PLANNING BOARD MEETING AGENDA

Re: Wickes Arborists – 11 McNamara Road
Response to Site Plan and Special Permit Review comments

The following are in response to comments prepared by Brooker Engineering, PLLC dated May 23, 2023.

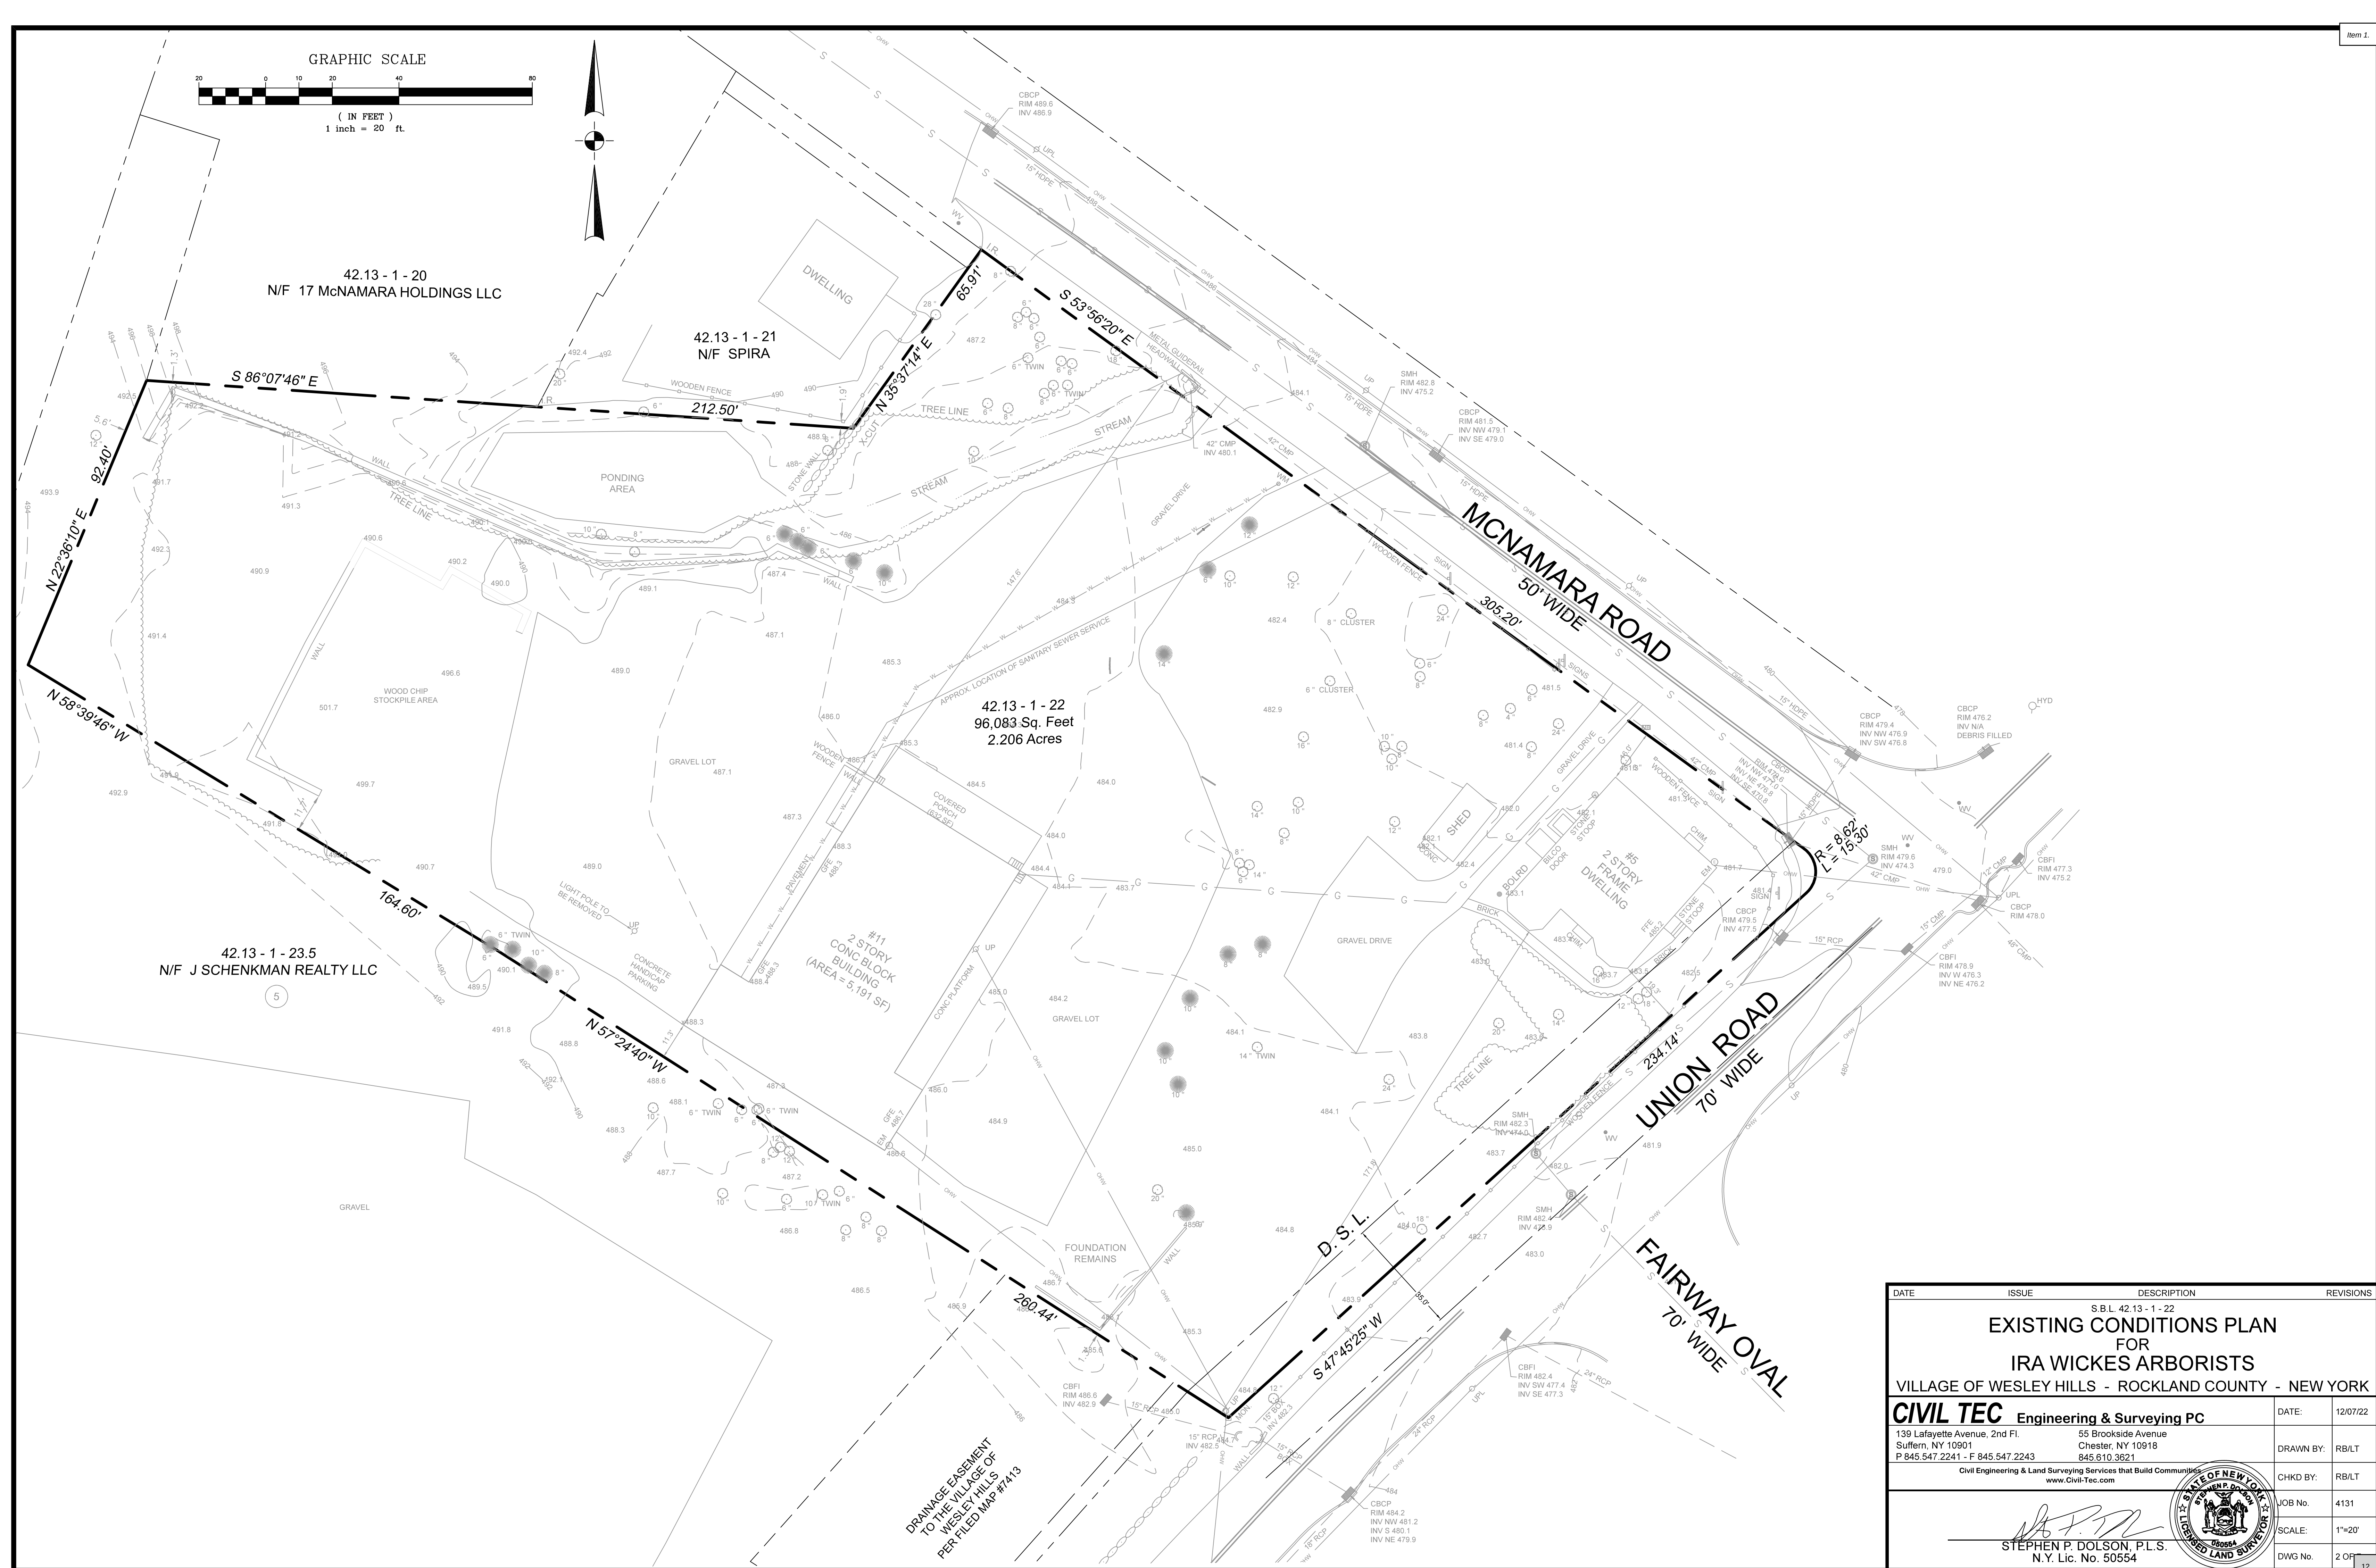
- 3. Existing material storage containment areas appear not to be in conformance with the Village code. Four 100 cubic yard containers are depicted on the plans and described in the narrative. Code allows a maximum of 25 CY for stone/gravel per container and 50 CY per container for other materials.**

- 4. Confirmation is requested by the applicant that gravel is a suitable finished surface for ADA parking & accessible route area.**

- 6. Proposed concrete curb limits to be confirmed. Previous plan set included only a limited area of concrete curb along the border of the rain garden to convey and pretreat stormwater runoff.**

9. **Various site plan elements appear to be absent from the previously approved site plan, including but not limited to:**

- a. “No left turn for trucks” signage
- b. Fire zone signage
- c. Proposed fence limits
- d. Block wall adjustments (or note current heights)
- e. Lighting Plan

Response: The Stipulation of Settlement provides the storage of 400 cubic yards of mulch and/or woodchips in storage structures with a 100 cubic yard capacity. No storage of stone and/or gravel is proposed.

Response: The ADA compliant parking spaces and accessible route are now being proposed to have concrete pavement.

Response: The Concrete curb is to be installed along the border of the rain garden to channel the flow into the rain garden through the pretreatment structures. The remaining concrete curbing has been removed.

Response: A thorough review of the approved site plan was performed, and revisions were made to the plans.

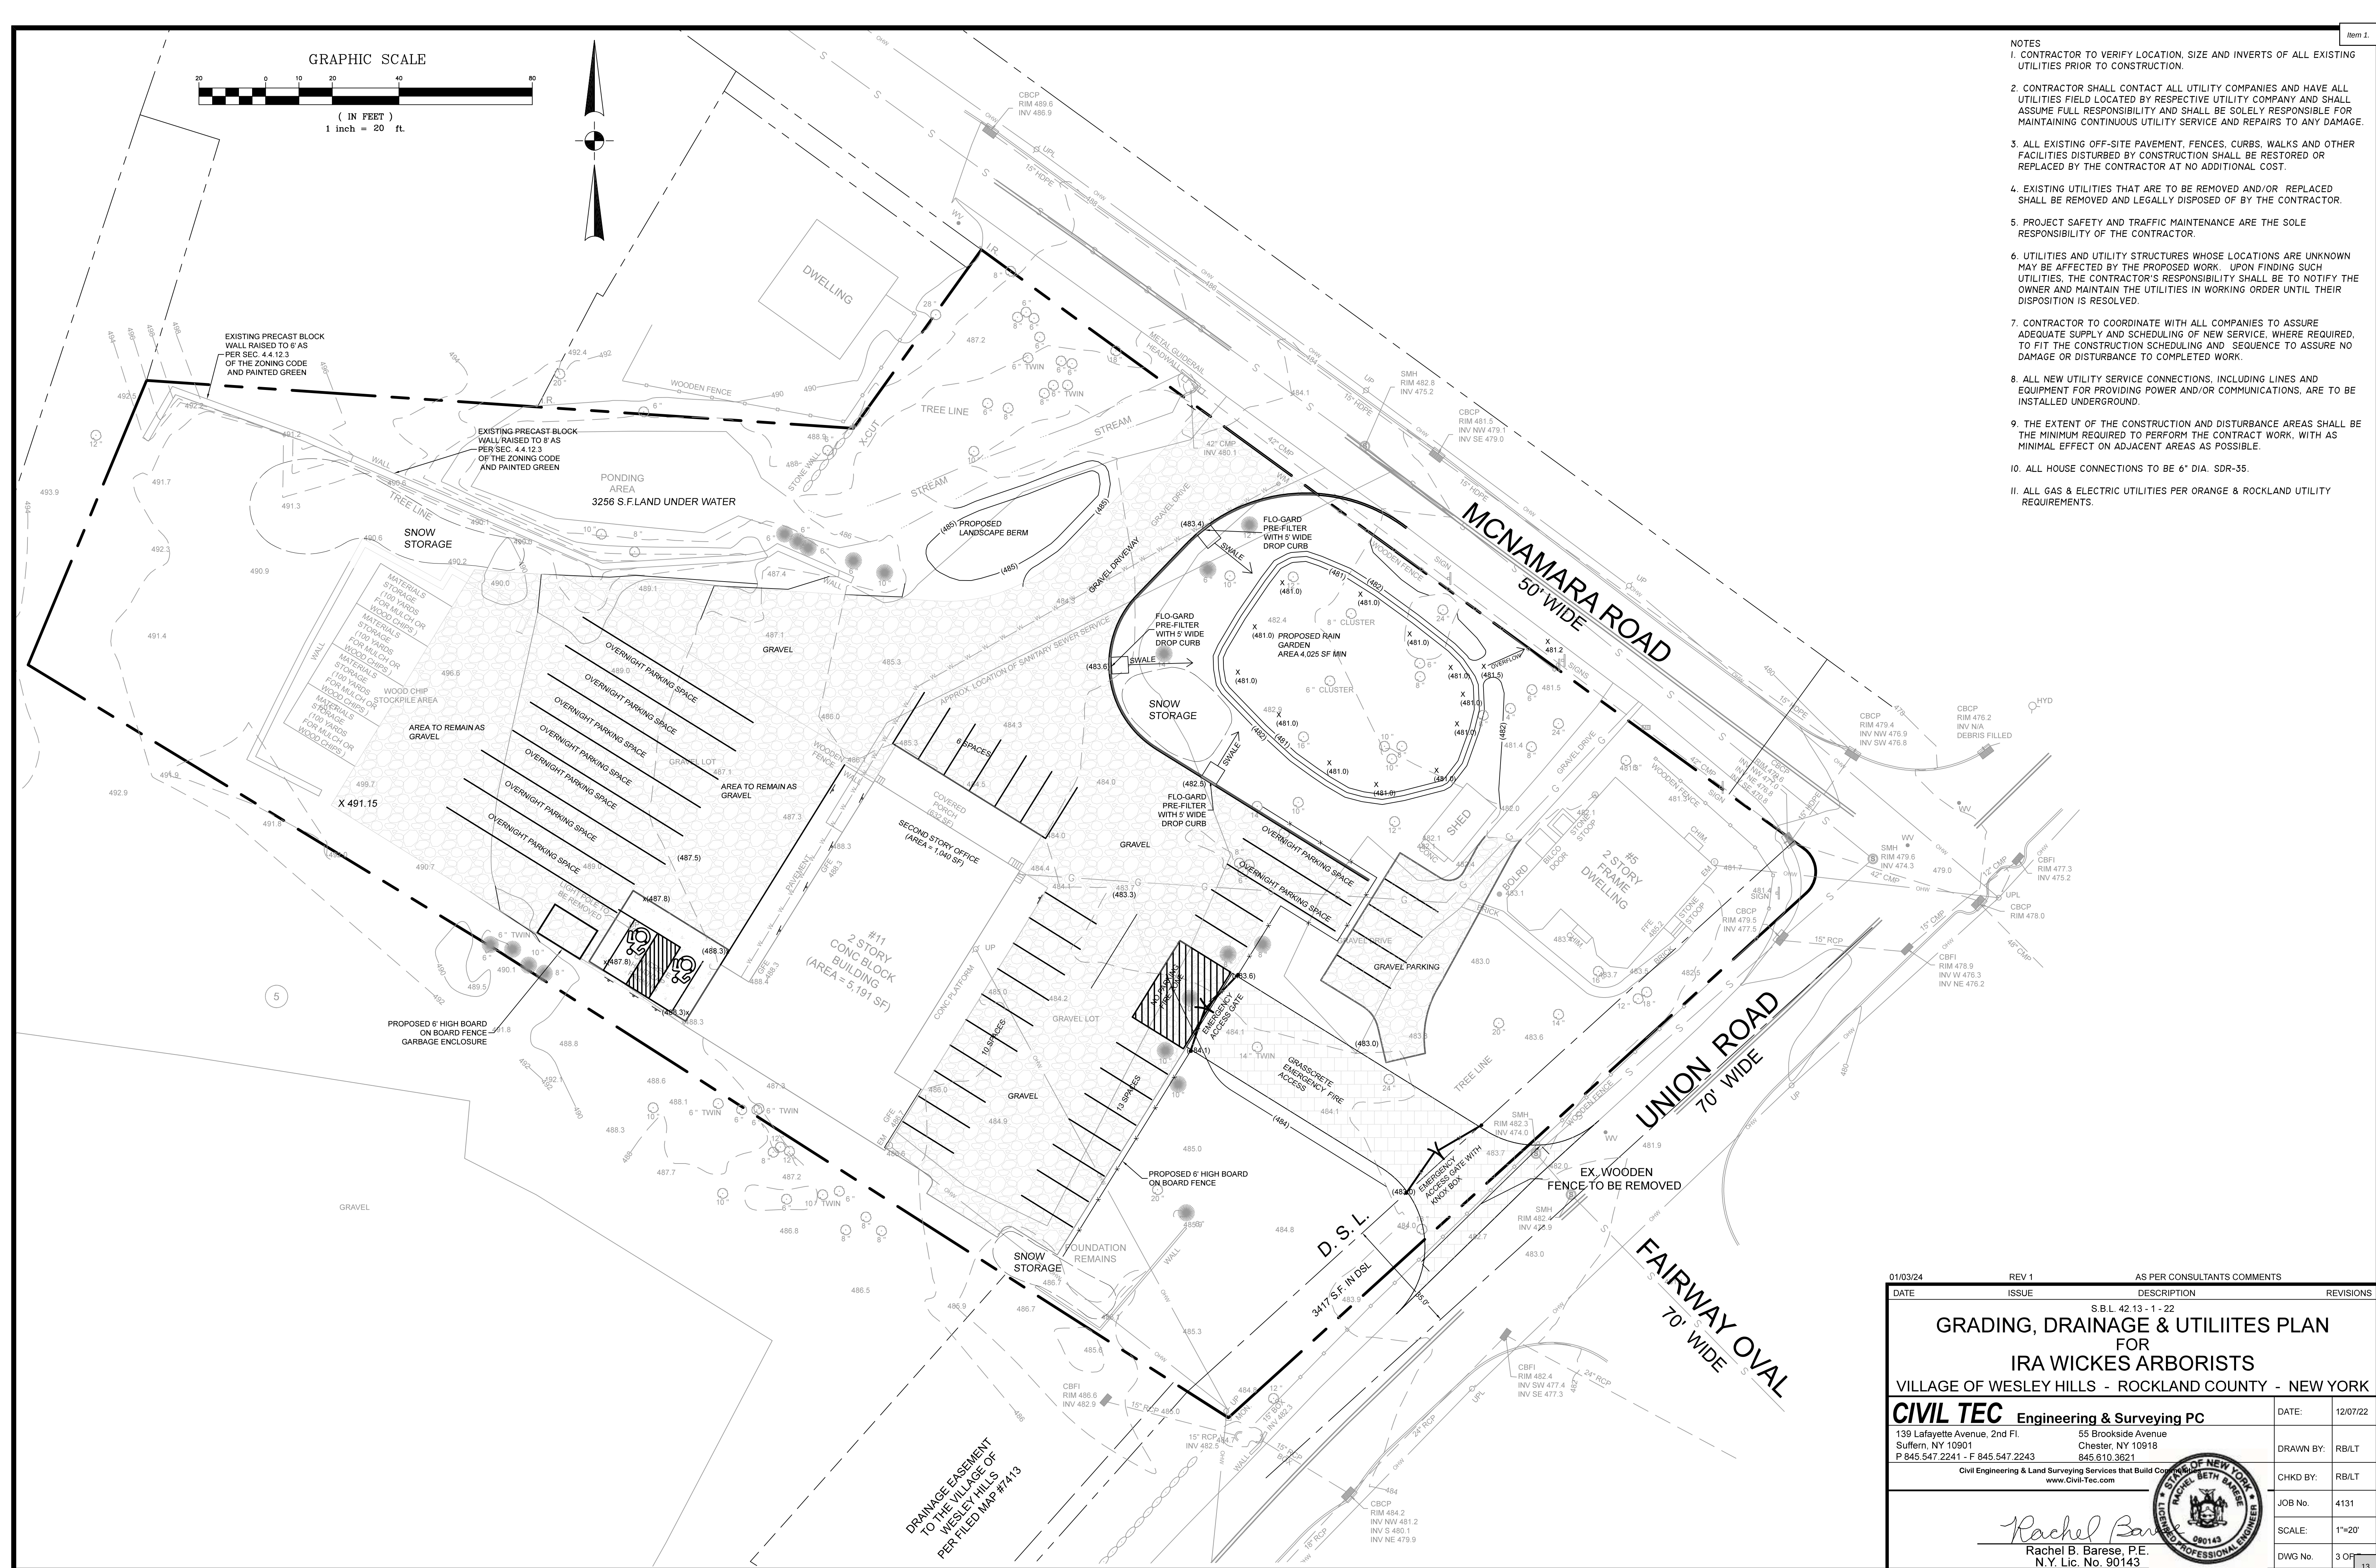
10. **Grading detail is limited. Additional spot grades shall be provided to demonstrate:**

11. **Additional drop curbs appear necessary to accommodate proposed configuration of catch basins/flo-gard prefilters. Outlet of catch basin to be clarified. Detail suggests a piped overflow is needed. Grading/inverts to be confirmed.**

- 13. The discharge point for the underdrain system and domed overflow riser are absent from the plan. Overflow invert, underdrain invert, and discharge location & invert shall be provided.**

Response: Additional spot grades have been provided to clarify the proposed grading in the named areas.

Response: An additional Drop curbs and an additional flo-gard pre-filter have been proposed. The overflow has been designed to flow overland in a grass swale to McNamara Road drainage system. An underdrain is not required in the rain garden if the soil infiltration rate is not sufficient. If soil testing determines an underrating is required, we will design it before construction.

Response: Overflow has been designed to flow overland in a grass swale to McNamara Road drainage system.

GRASSCRETE PERVIOUS PAVEMENT DETAIL

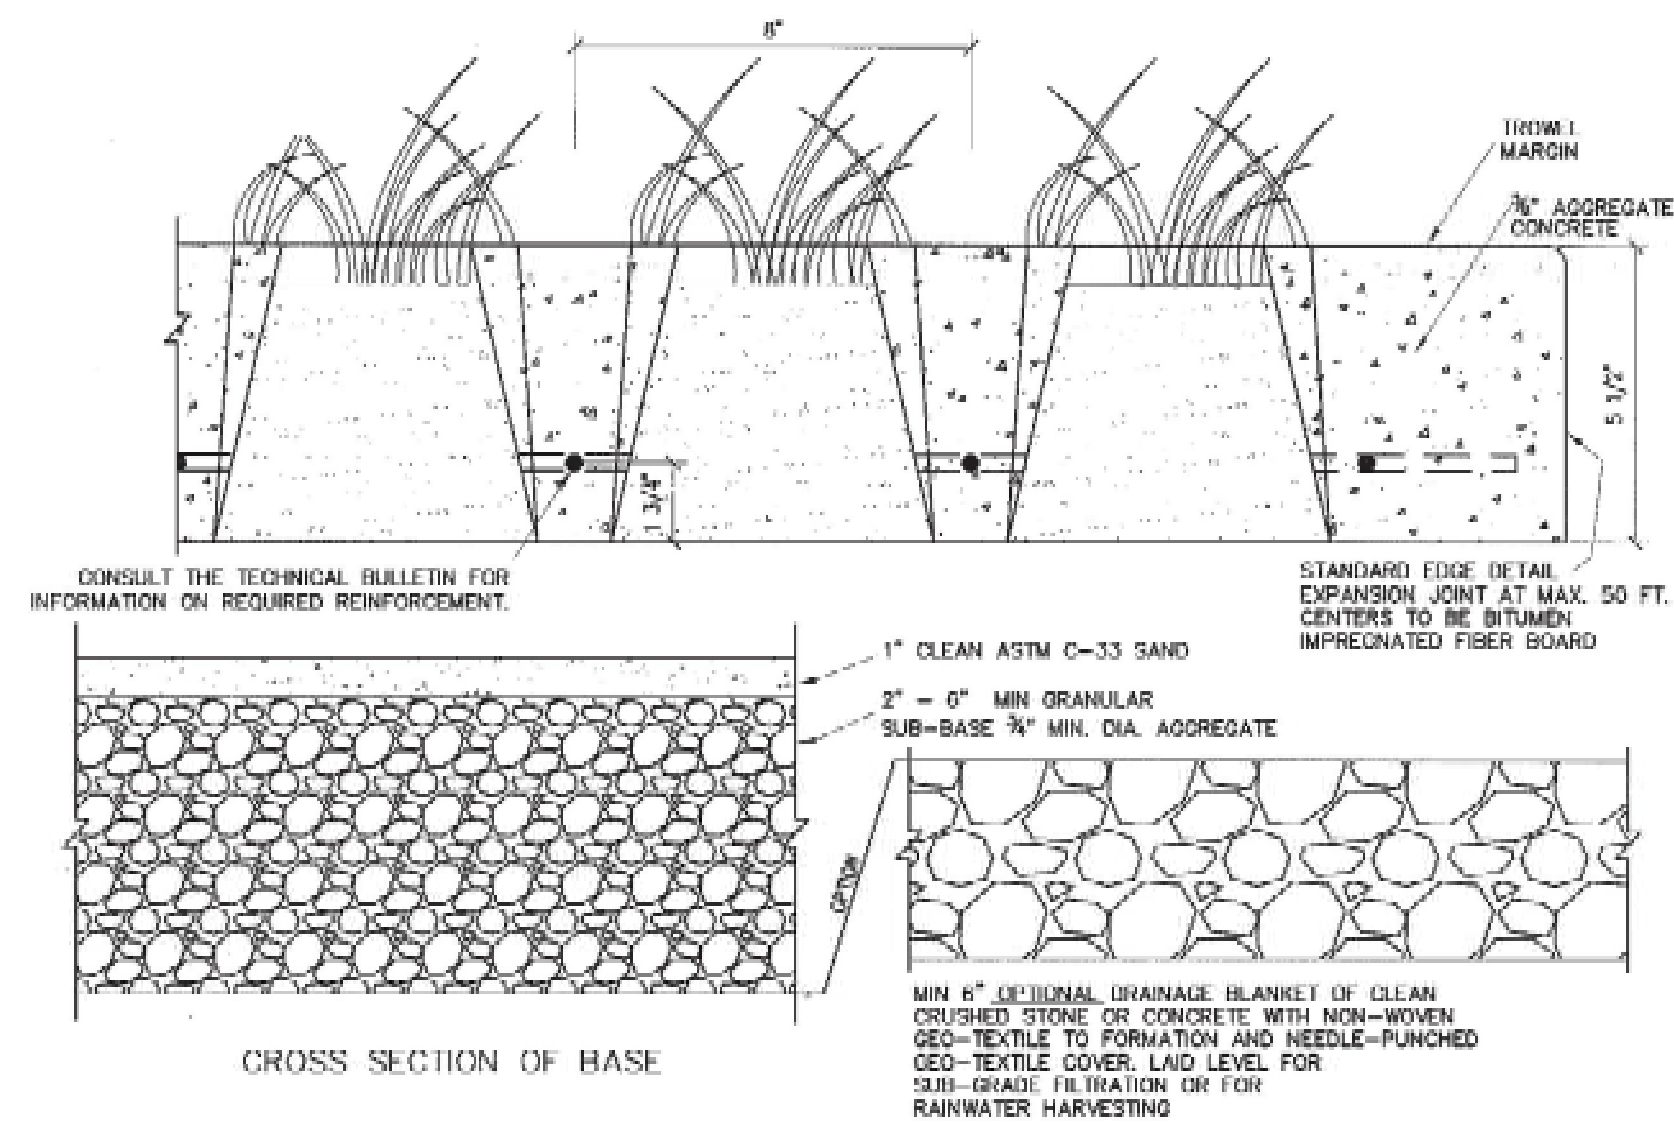
- 16. Grass-crete detail/cross section to be provided.**

Response: Additional Details have been provided.
